Technical Note

Land at Woodgate Centre, Woodgate

20-061-016 Rev -

Response to WSCC Highways Comments

Appendix B Drawing 20-061-039

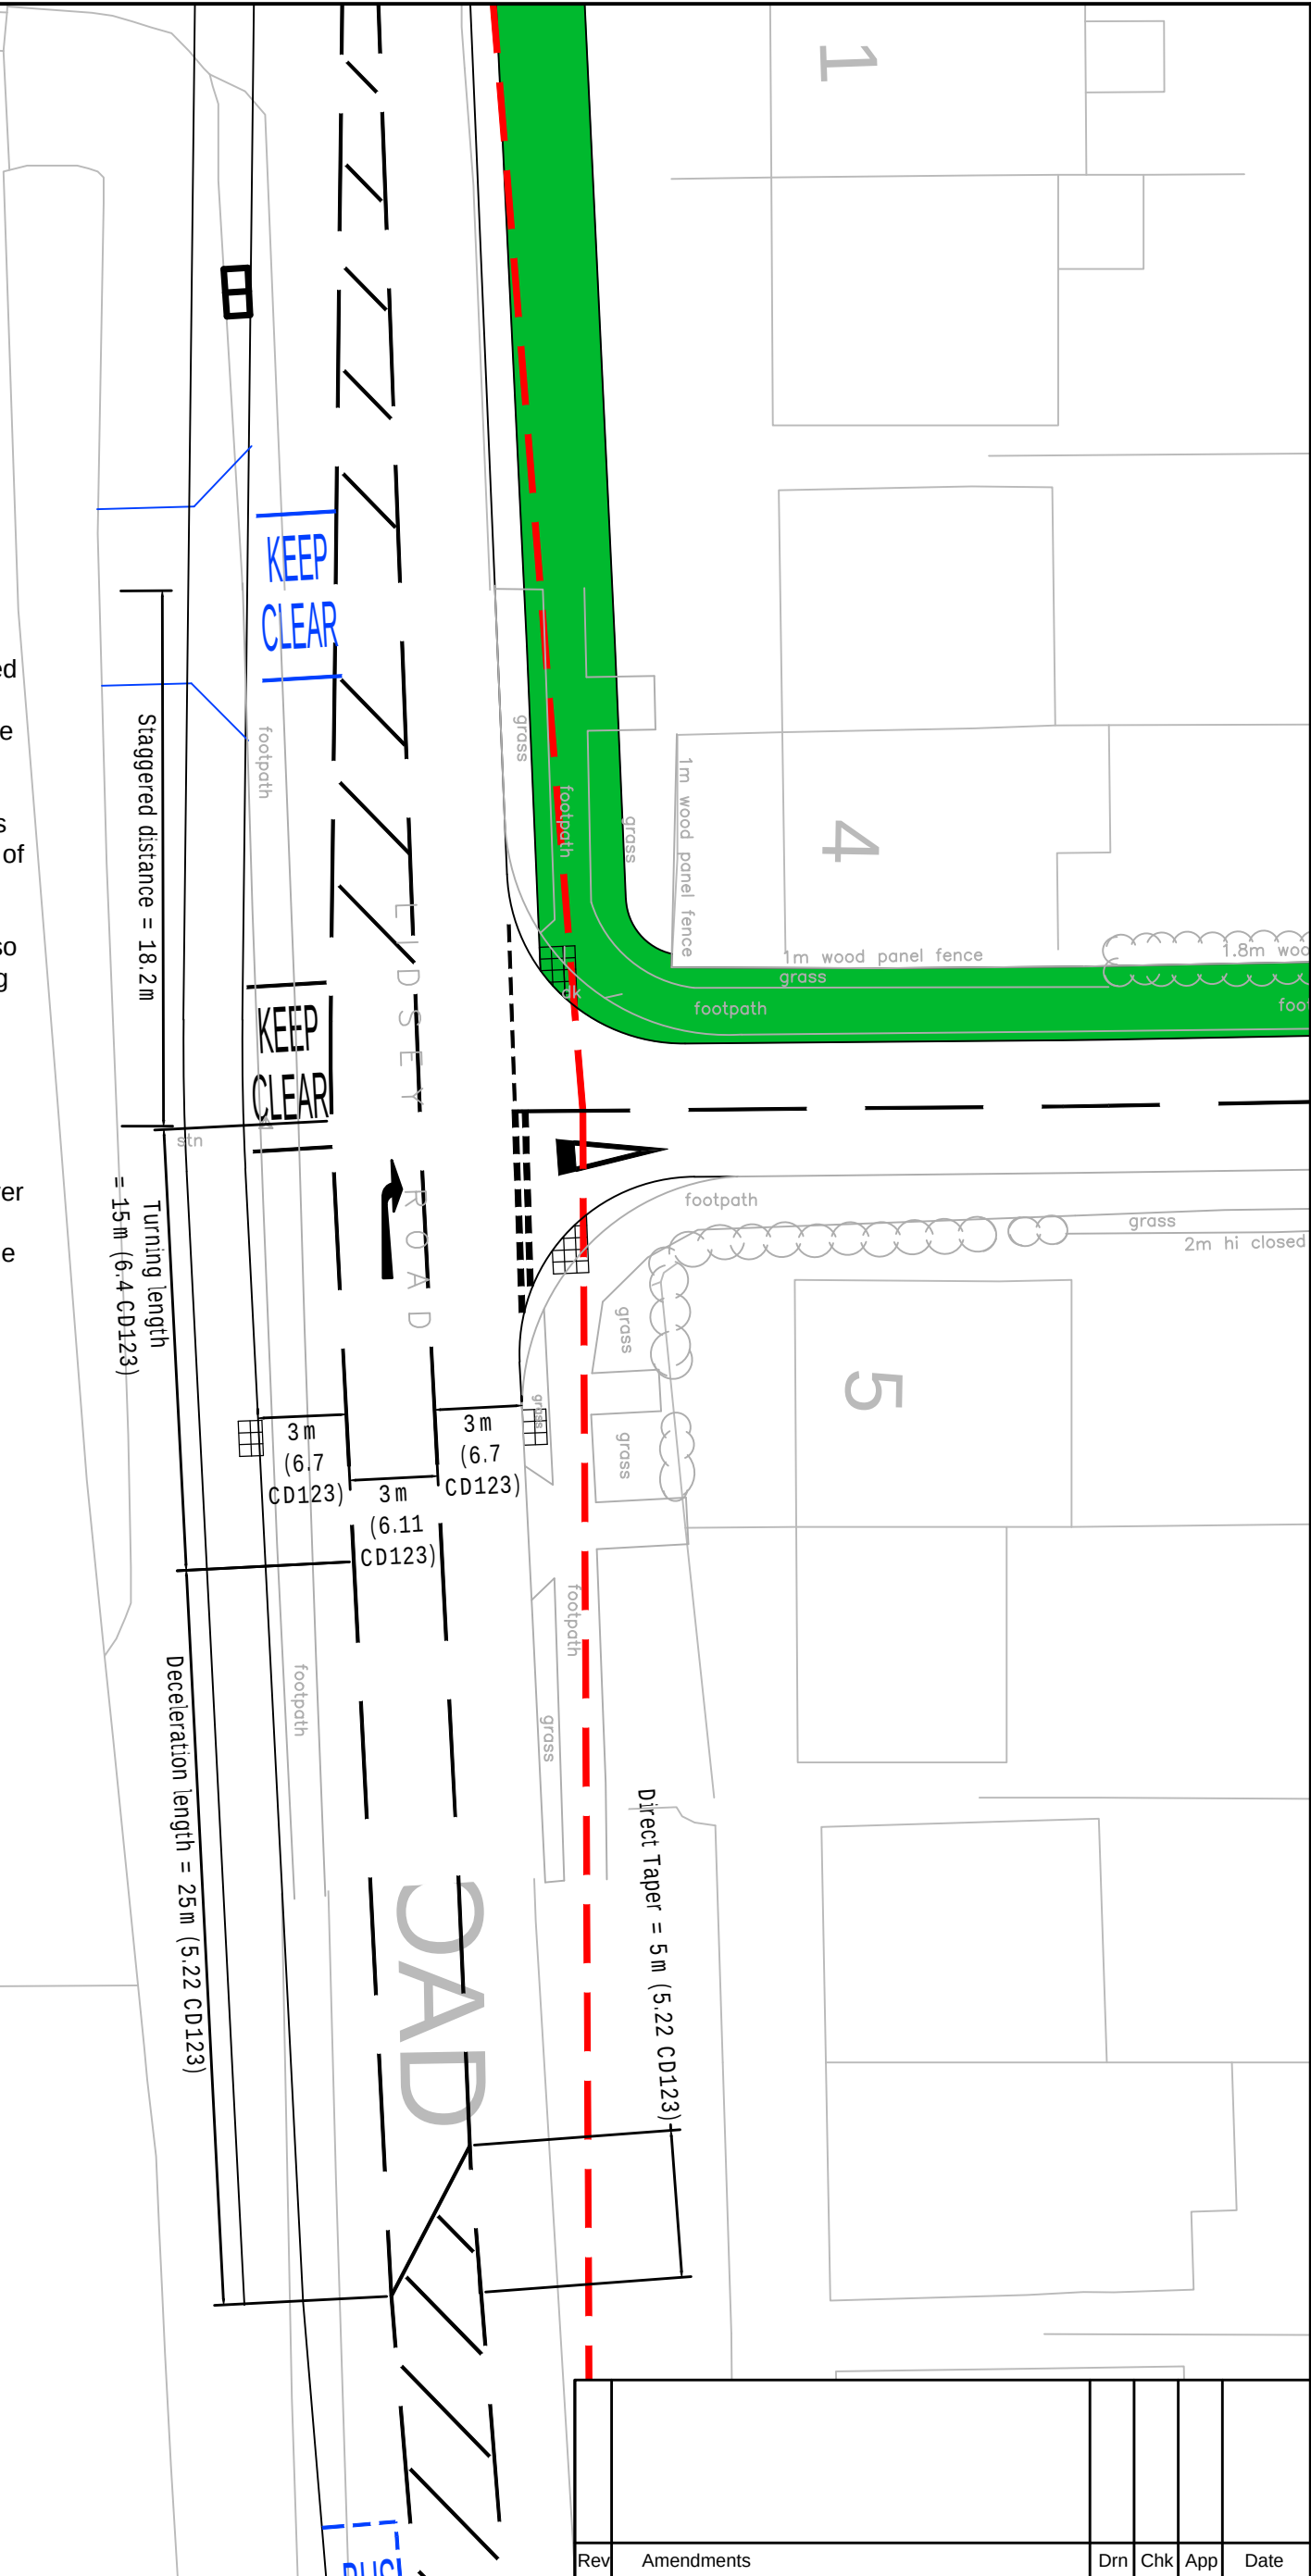
“a formal design check of proposed right hand turning facility

- 2.1.2 It is noted that the junction and shared cycle/footway have been through an independent Stage 1 Safety Audit previously provided to the highway authority, together with a Designers Response. That said, drawing 20-061-039 (**Appendix B**) shows the dimensioning achieved by the right turn lane design, it also highlights the references from CD123 where the required values are obtained. All values meet the minimum requirements.

Taper length (measured as 60m) based on the requirement for a minimum 1:20 taper, based on the current 1/2 road width (3.4m) and design width (9m) which would require a length of 52m

Appendix C Drawing 20-061-040

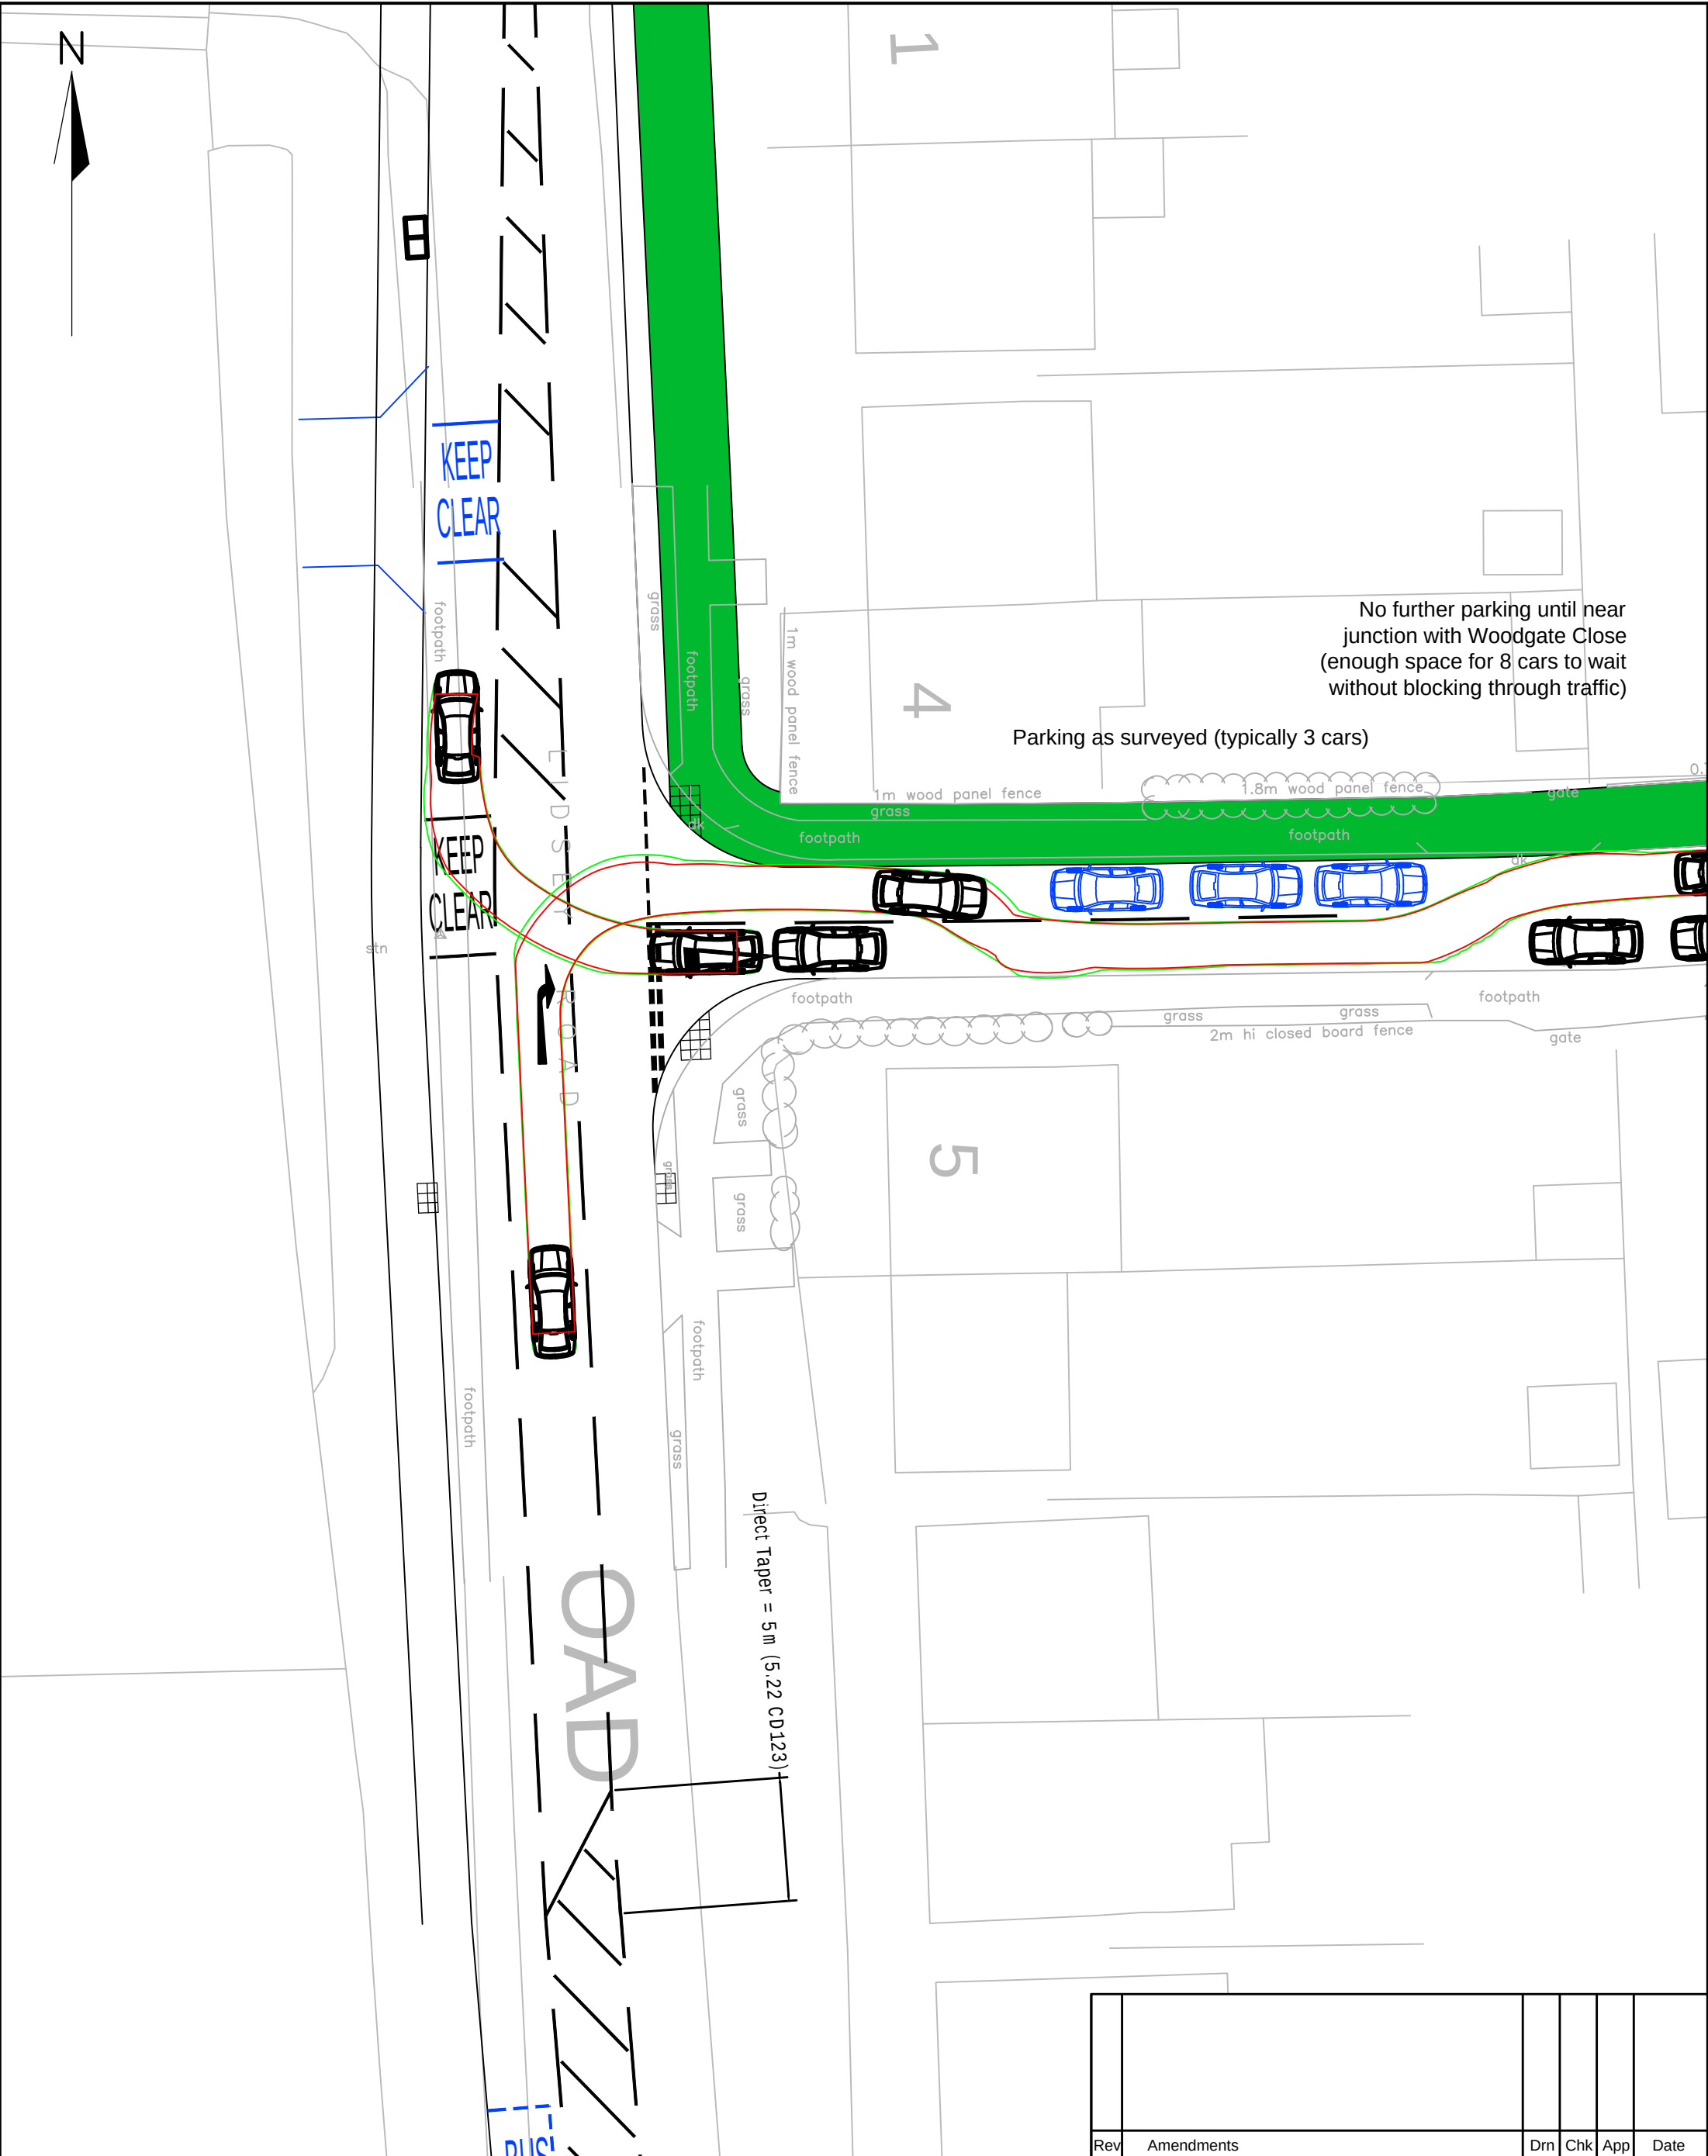
a plan showing queues on Woodgate Road when railway crossing gates are down and swept-path diagrams at junction with cars parked at the junction

- 2.1.3 This is covered in more detail below (paragraphs 3.1.4 to 3.1.10), however drawing 20-061-040 (**Appendix C**) provides an indication of how Woodgate Road will operate in the circumstances detailed.

- 3.1.9 An indication of how Woodgate Road might operate in these circumstances in terms of interaction with opposing and parked vehicles is shown on drawing 20-061/040, contained in **Appendix C**.
